EIA Scoping Direction

DNS CAS-03018-G7G6H7

Mynydd Ty-Talwyn Energy Park

11/04/2024

Figure 1 – Illustration of PROWs crossing the site.

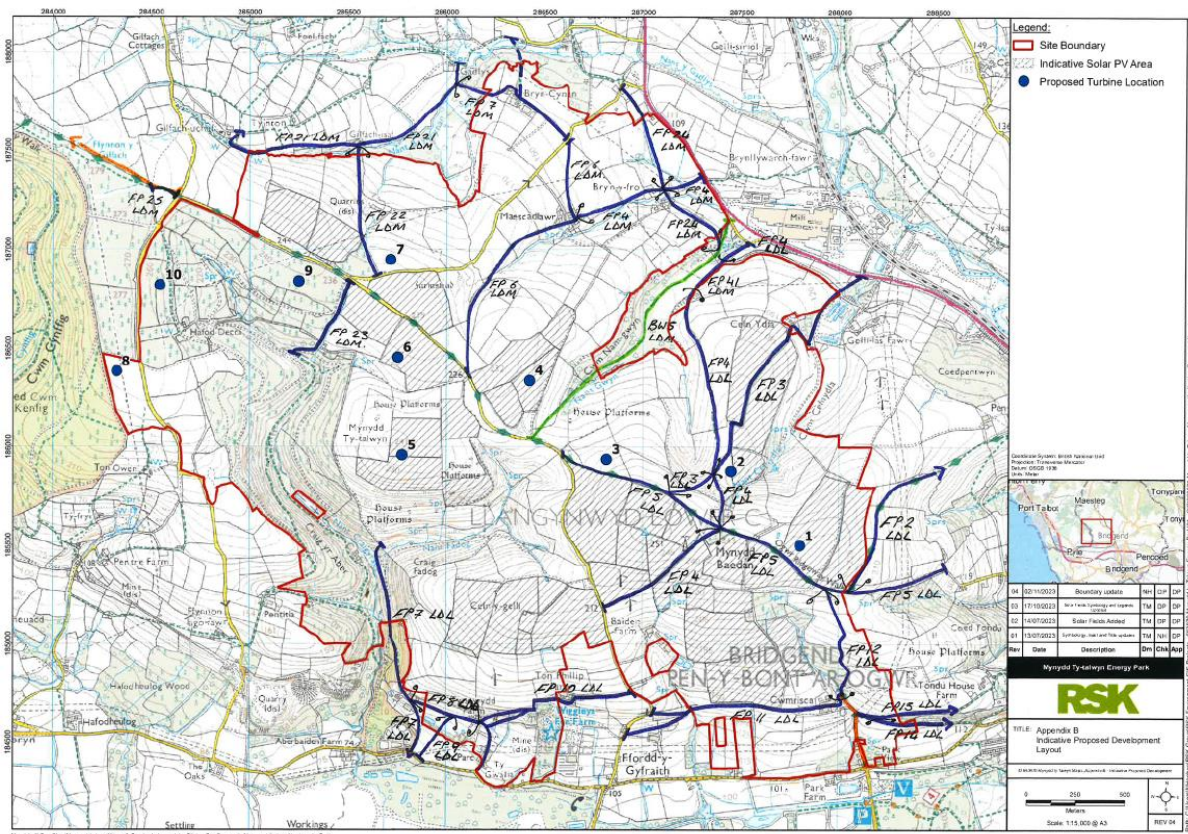
It should be noted that two registered public footpaths also abut the application boundary of the proposed development. The approximate alignments of those footpaths, as they are currently shown on the Definitive Map, are shown coloured purple on the indicative proposed development layout plan. These are Footpath 2 Llangynwyd Lower (FP 2 LDL) and Footpath 25 Llangynwyd Middle (FP 25 LDM).

There are also 4 Definitive Map Modification Orders (DMMO's) affecting the area concerned, these are shown by solid orange lines on the indicative proposed development layout plan. Below is Bridgend County Borough Council's reference and a description of each DMMO.

It is pleasing to note that the applicant is aware that there are a number of public rights of way (PRoW) within the site boundary as well as a promoted route, namely the Ogwr Ridgeway Walk as mentioned in the Information to support a Scoping Opinion Request (Paragraph 5.9.7). It is also pleasing to note that the applicant, in the same document, is aware of the need to temporarily and/or permanently divert some of the PRoW (Paragraph 5.9.8) during construction and should the development receive planning permission.

There is also mention that an Outline Access Management Plan (OAMP) will be prepared outside of the EIA process and submitted in support of the DNS Application. The Rights of Way Section would advise, however, that it was not previously aware of this as it has received no correspondence from the applicant in relation to this proposal. Until such time as further correspondence/information is received in relation to the OAMP outlining how the applicant would wish to deal with the number of PRoW affecting the site, the Rights of Way Section are unable to make further comment.
